# Dawn Mill and the Spokane Tribe

# Alternative Concentration Limits (ACL)

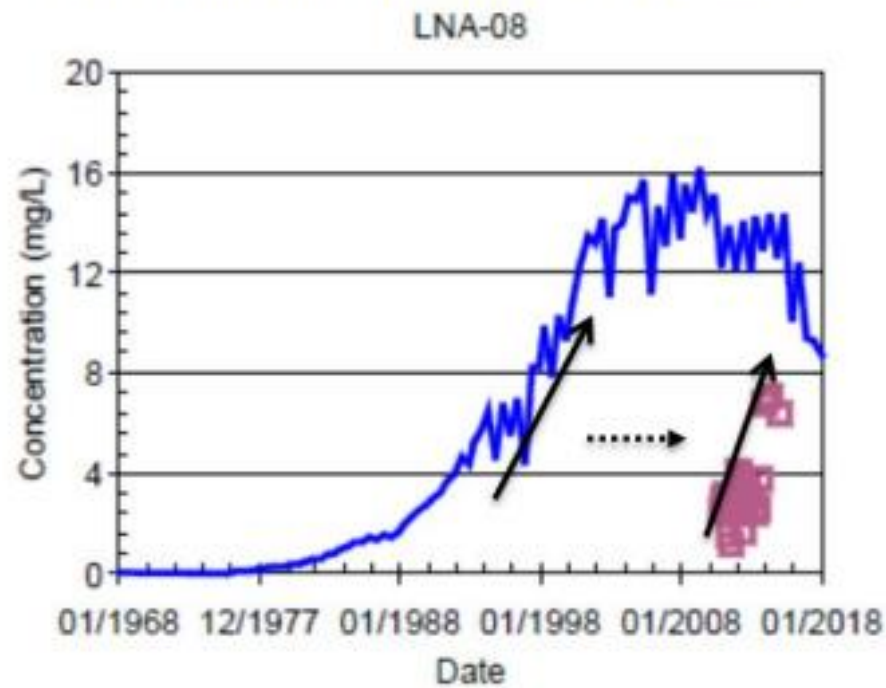
**Figure 3. Site data show that concentrations of uranium are increasing in multiple wells (LNA-08, XOSA-5, and XOSA-18) in the northern plume area. In addition, concentrations at several upgradient wells (located toward the center of the plume) have remained constant over the past decade (e.g., XOSA-21, XOSA-23, XOSA-25), contrary to modeled results presented in the ACL that show declining trends.**

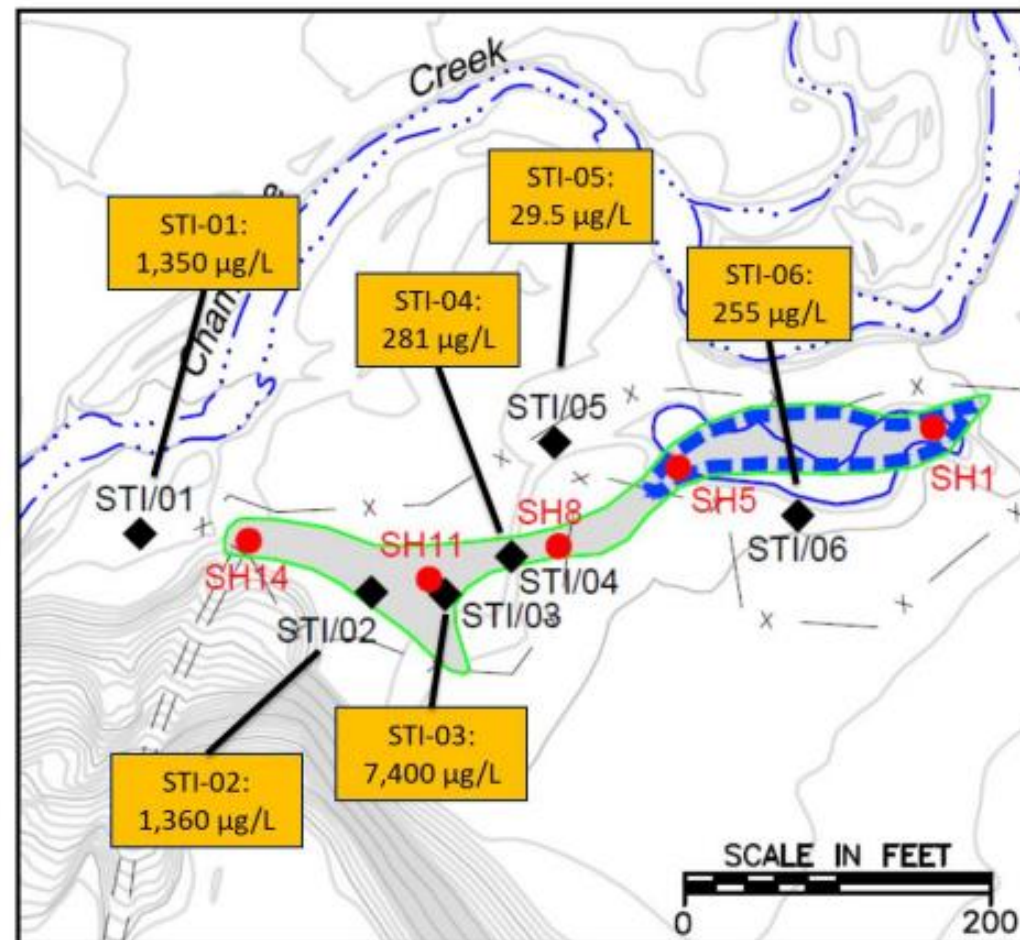
**Figure 3. Model output for well LNA-08 (blue line) compared to measured samples (maroon squares).** Black arrows have been added to show that the measured increases in uranium concentrations between 2008 and 2016 follow a similar trend predicted by the model ~ 15 years earlier. The original figure is from Figure 5-8 in Appendix A of the ACL Application.

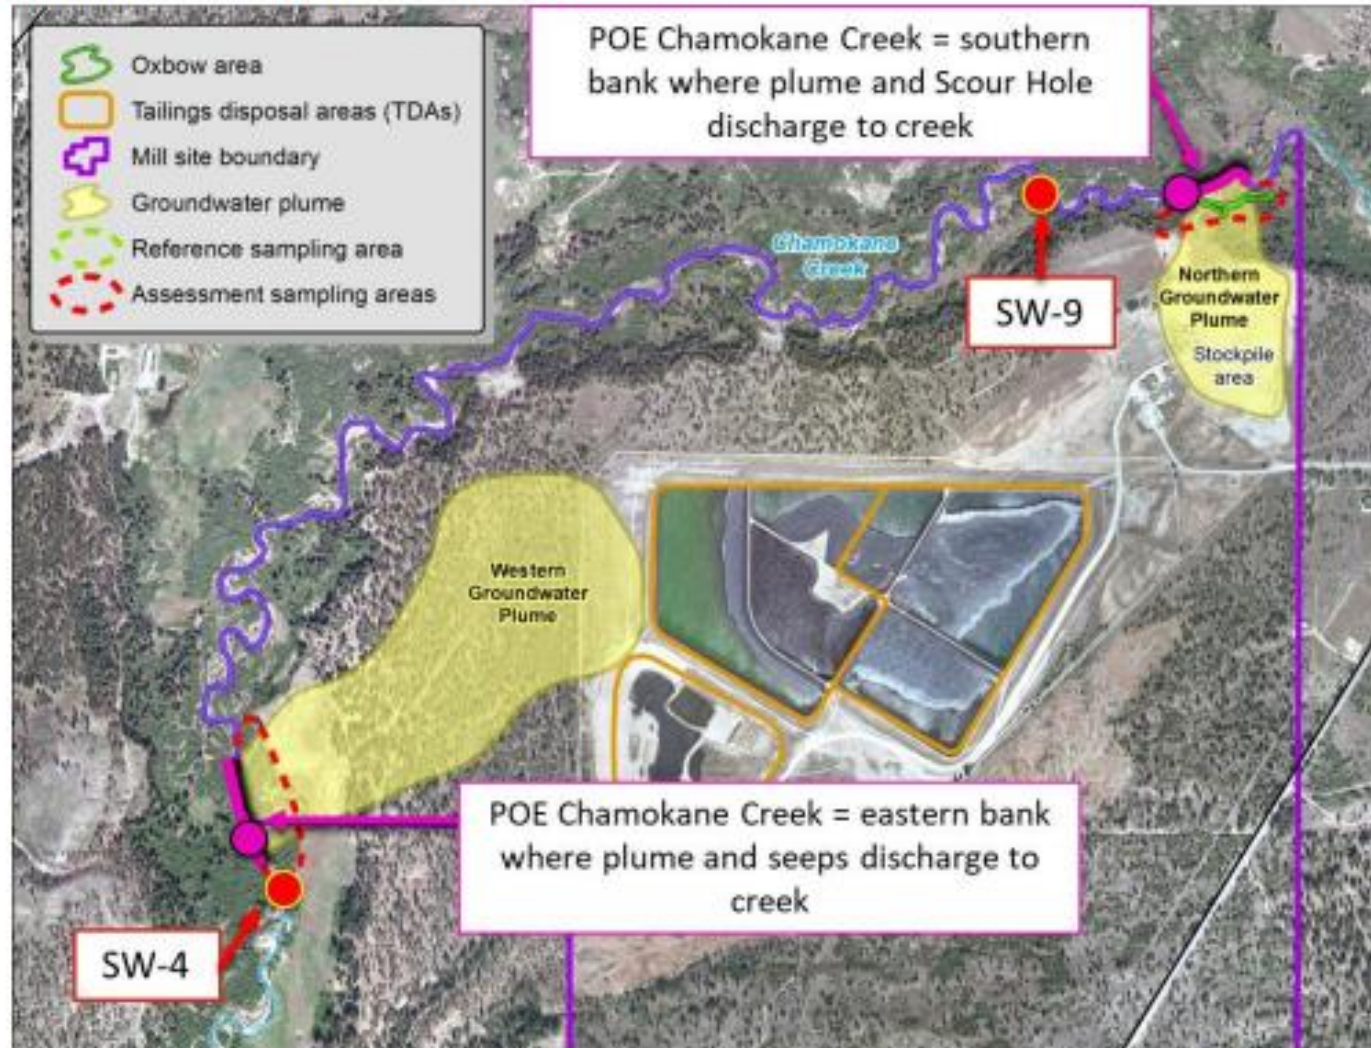
**Figure 4. Uranium concentrations in the Scour Hole collected by STI in April 2018.** Uranium concentrations on the west side of the Scour Hole are as much as three orders of magnitude higher than the average values DMC presented with their proposed POE locations (SH1 and SH5: 15  $\mu\text{g/L}$ ).
